Task Force 2 – Receptacles

Recommendation for Part I: Statement of technical rationale and justification

Recommendation for Part II: Text of the regulation

5.2.1.1 Fuelling receptacle requirements

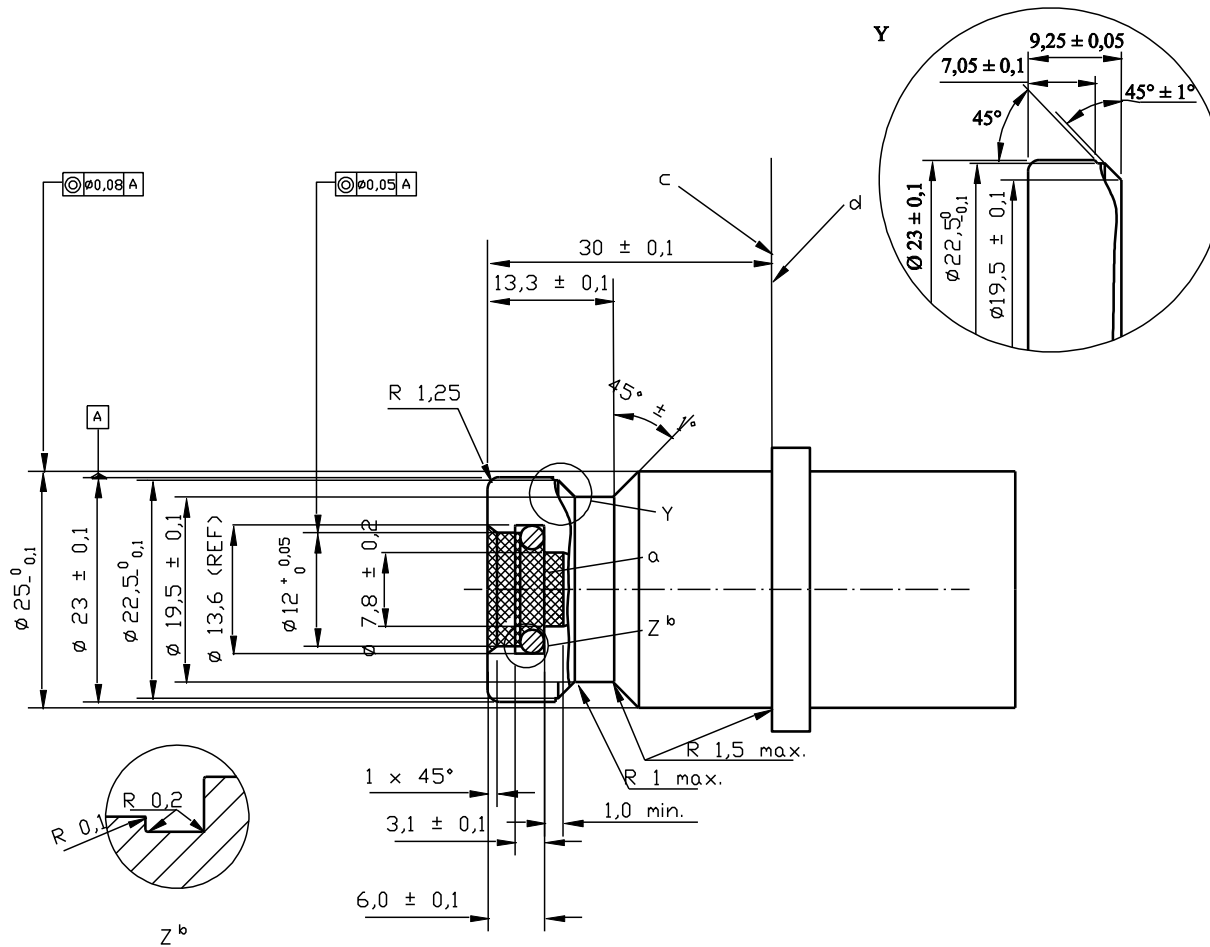
5.2.1.1.1 The fuelling receptacle shall prevent reverse flow to the atmosphere. Test procedure is by visual inspection. The geometry of the fuelling receptacle shall be designed as specified in figures 1-4. [Alternatively, another design can be chosen if the receptacle geometry design provides, at a minimum, the same level of safety and interoperability as the design shown in ISO 17268:2019.] In that case it shall also be ensured, e.g., by additional means, that fueling with a higher NWP nozzle cannot be made with lower NWP receptacle designs.

Figure 5 — Example hex design

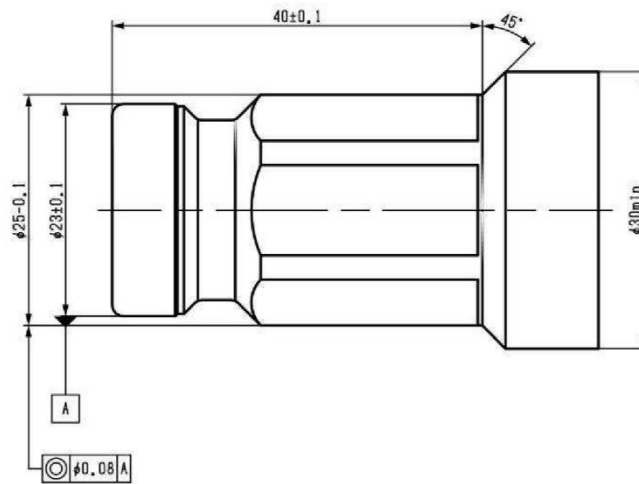
[Figure 5 is presented as an example countermeasure against nozzle-receptacle freezing issues.]

Note: This design is an example countermeasure against freezing issues.
